**CITY OF MERIDIAN
FINDINGS OF FACT, CONCLUSIONS OF LAW
AND DECISION & ORDER**

Case No(s). H-2021-0021

SUBJECT: H-2021-0021
Prevail North Subdivision

Annexation & Zoning of 5.63 acres of land with an R-8 zoning district and a preliminary plat consisting of 18 single-family residential lots and 3 common lots on 5.25 acres of land.

B. Preliminary Plat (dated: 5/7/2021)

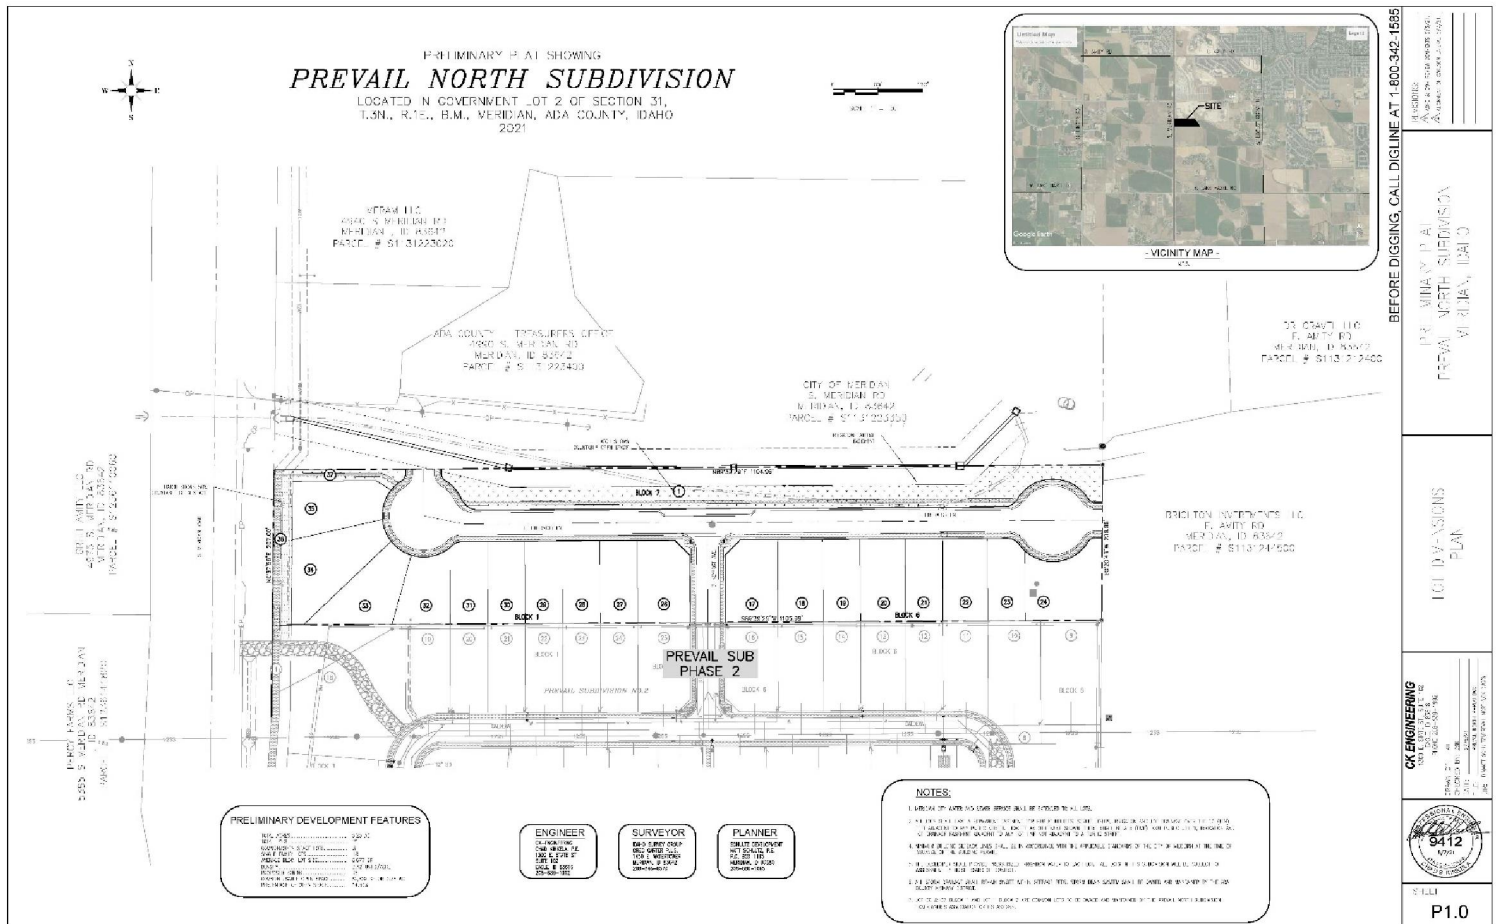
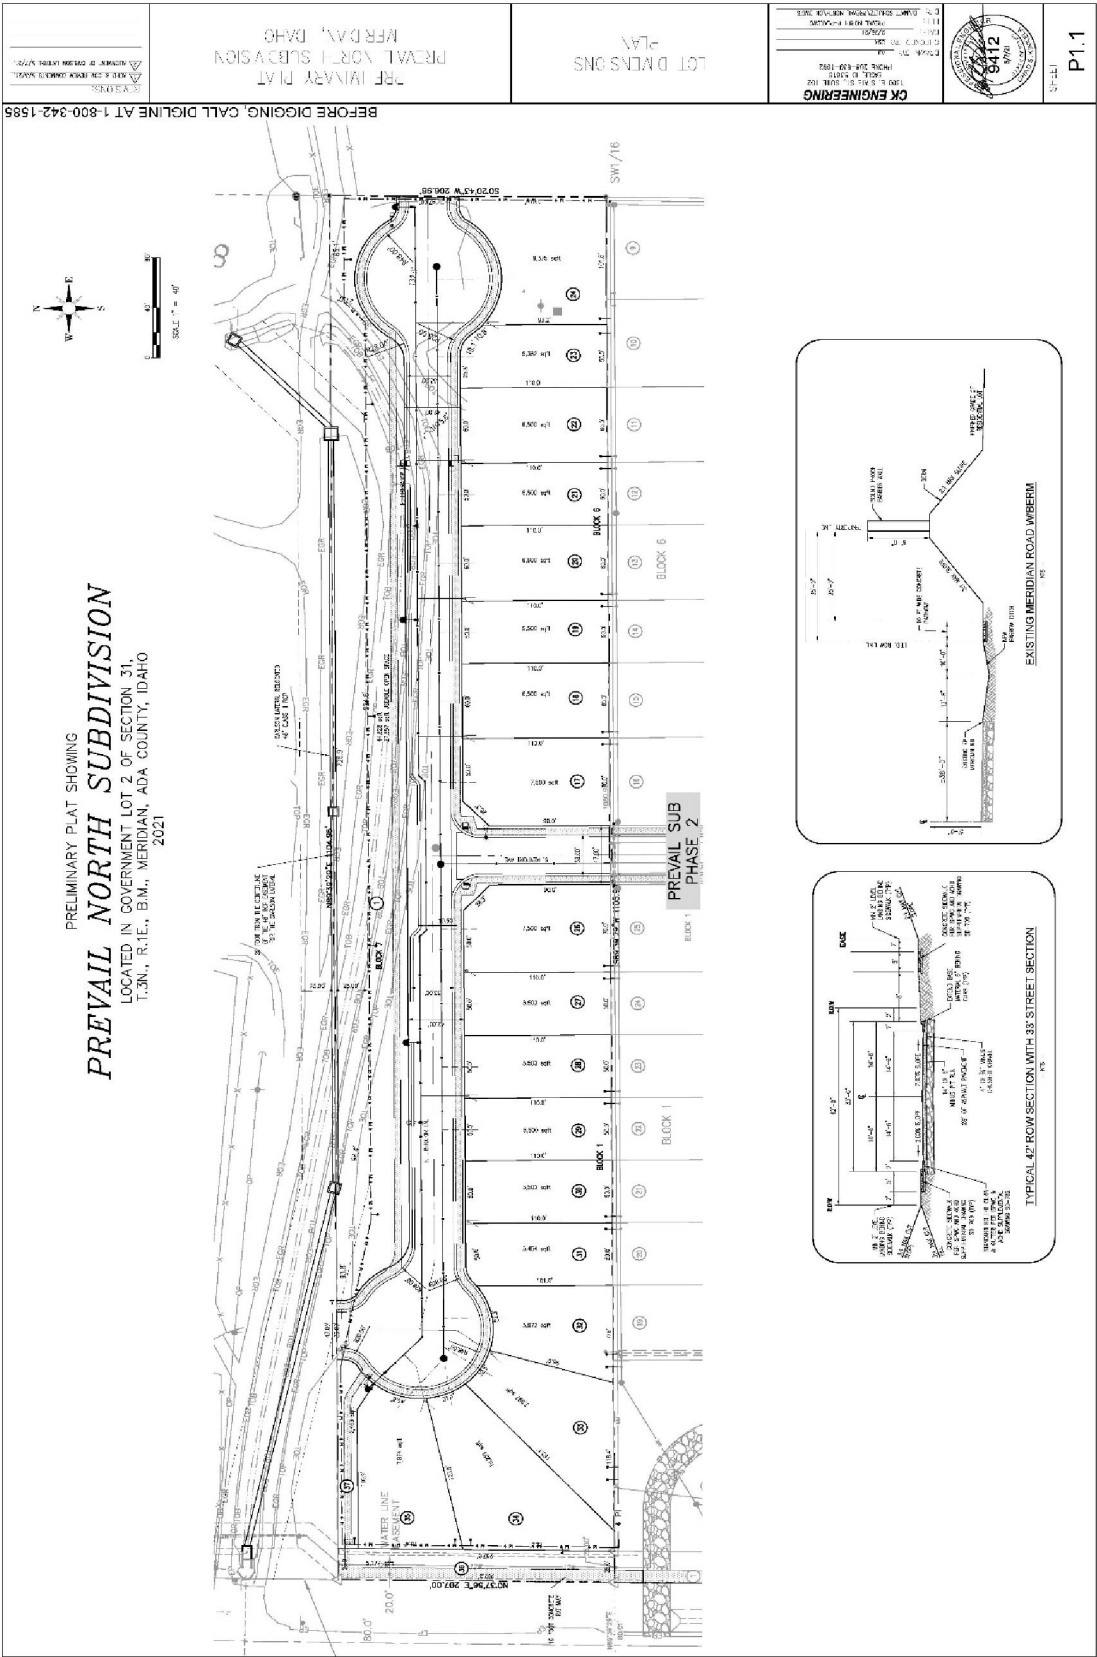
2. The preliminary plat included in Section VII.B, dated May 7, 2021, shall be revised as follows prior to submitting for Final Plat approval:
 - a. Revise the plat to show the landscape buffer common lot along Meridian Road to be at least 35 feet wide consistent with the required dimensional standards along an entryway corridor or apply for Alternative Compliance, per UDC 11-5B-5.

- b. Add a plat note stating that direct lot access to S. Meridian Road/SH 69 is prohibited.
 - c. Revise the plat to remove the stub street from the west cul-de-sac to the north property boundary, per the approved City Council waiver.

D. Color Landscape Plan – Prevail Subdivision Overall

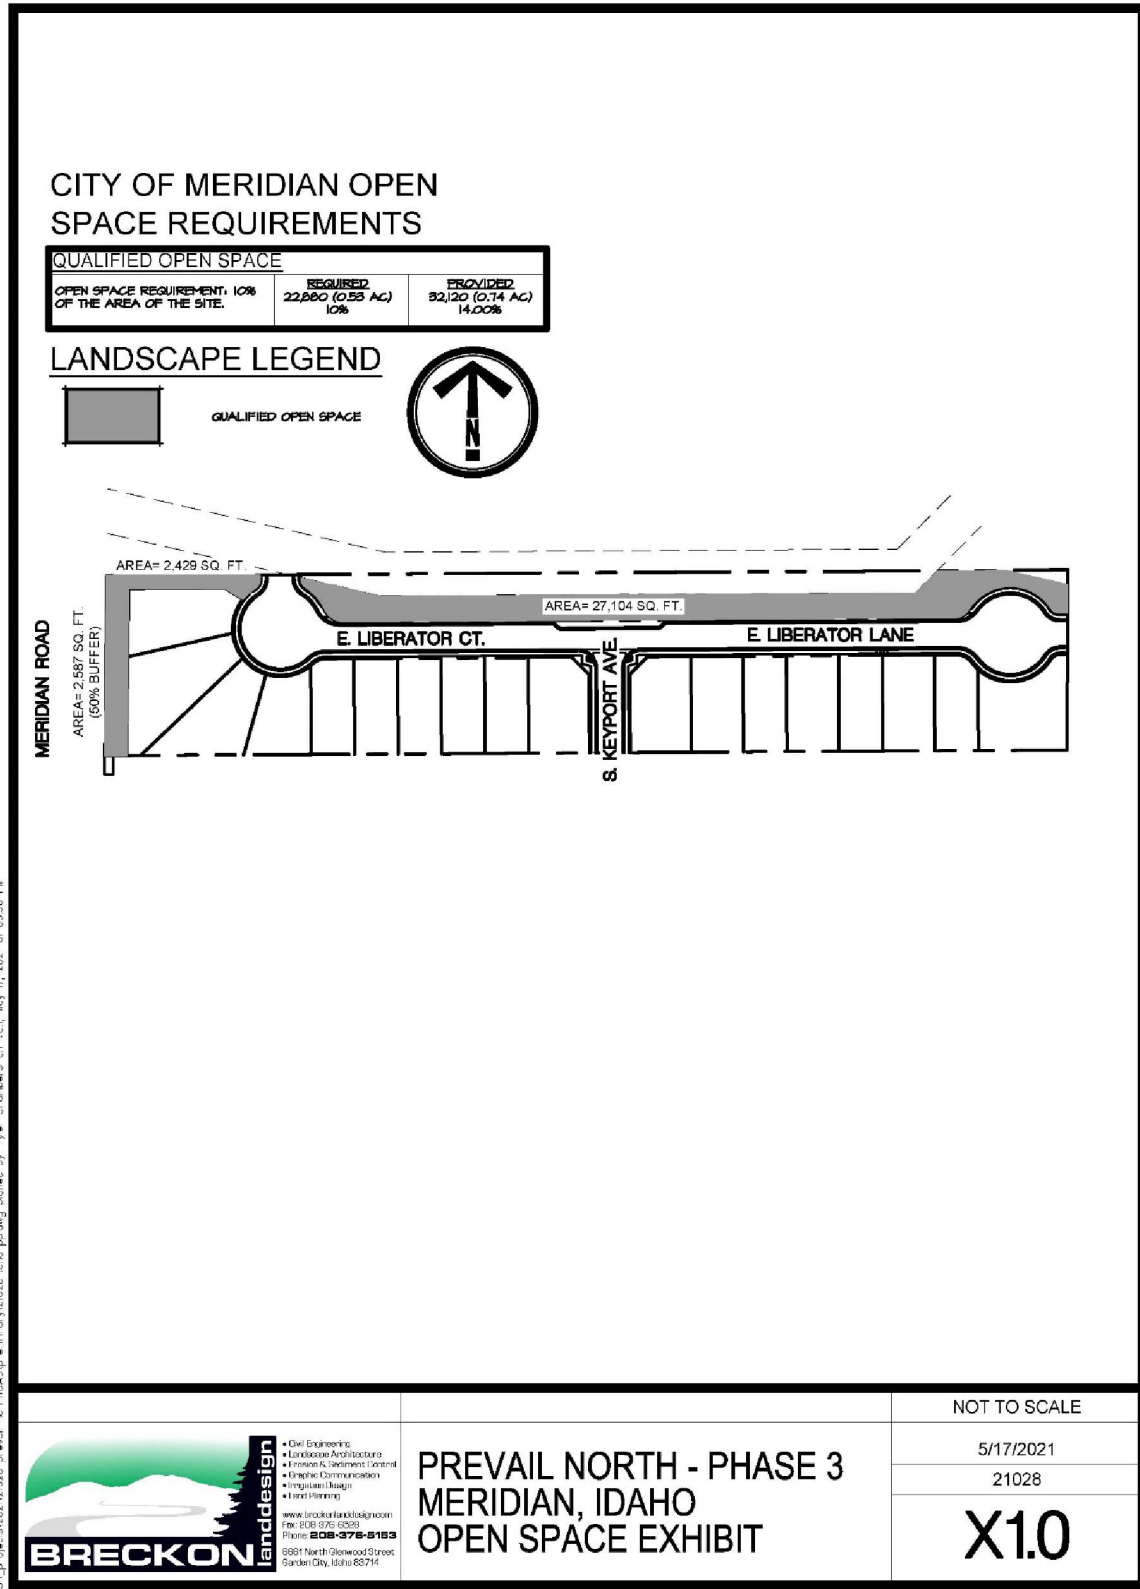
4. The landscape plan included in Section VII.C, dated ~~March~~ May 17, 2021, shall be revised as follows prior to submitting for Final Plat approval:

- a. Revise the plan to show the required landscape buffer along Meridian Road to be 35' instead of 25' or apply for Alternative Compliance, per UDC 11-5B-5.

- e. Any landscaping within the ITD right-of-way shall be landscaped in accord with UDC 11-3B-7C.5.
5. Future development shall be consistent with the minimum dimensional standards listed in UDC Table 11-2A-6 for the R-8 zoning district.

E. Open Space Exhibit —NOT APPROVED dated: 5/17/2021

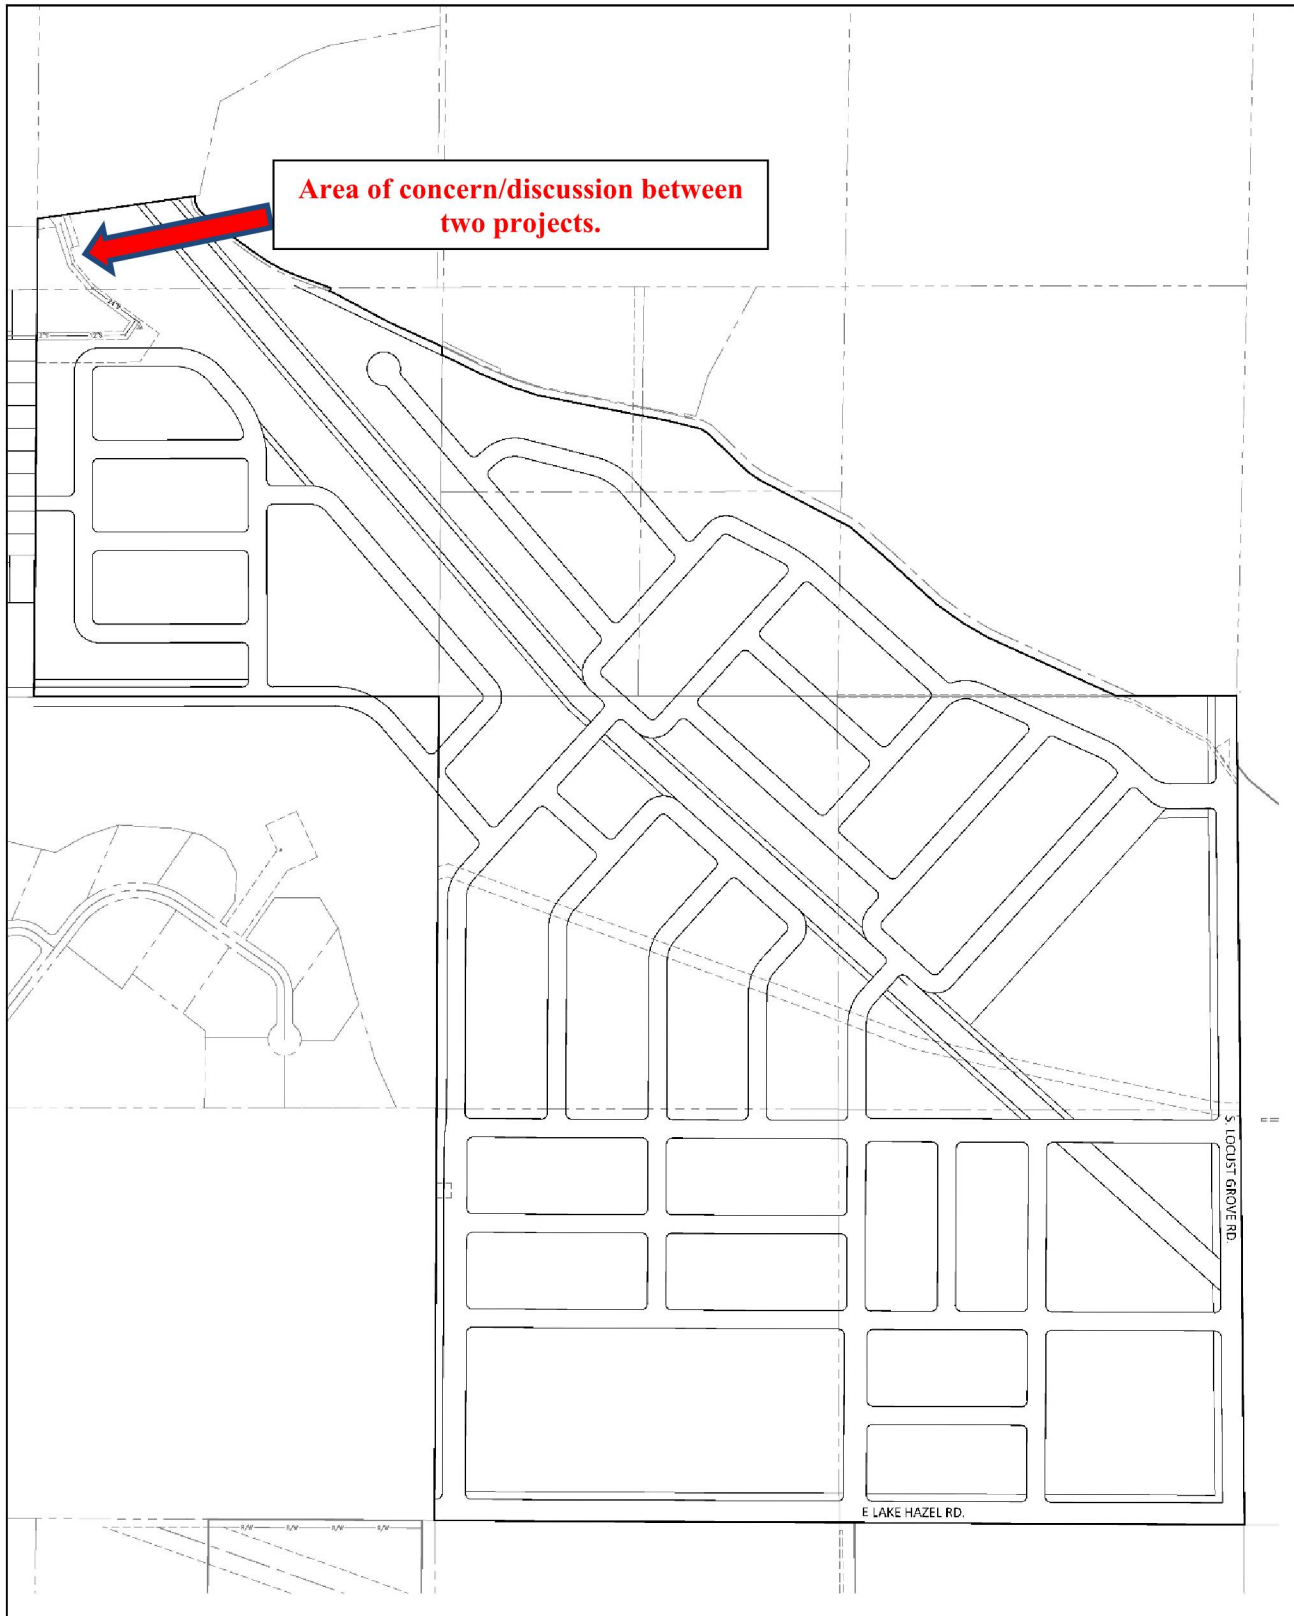
of the 5.25 plat area. However, not all of this area is qualifying after receiving the revised landscape plan that fences off a section of the open space lot that is impeded by the irrigation easement for the rerouted Carlson Lateral. After removing this area, the area of qualified open space is 32,120 square feet (0.74 acres) or 14% of the plat area. The proposed qualified open space still exceeds the minimum code requirements by approximately 10,000 square feet. Furthermore, this calculation uses the 25' landscape buffer width along Meridian Road instead of the required 35' width. Therefore, the actual amount of qualified open space should be slightly larger. The Applicant should correct the open space exhibit to reflect both the revised layout and the correct amount of qualified open space.
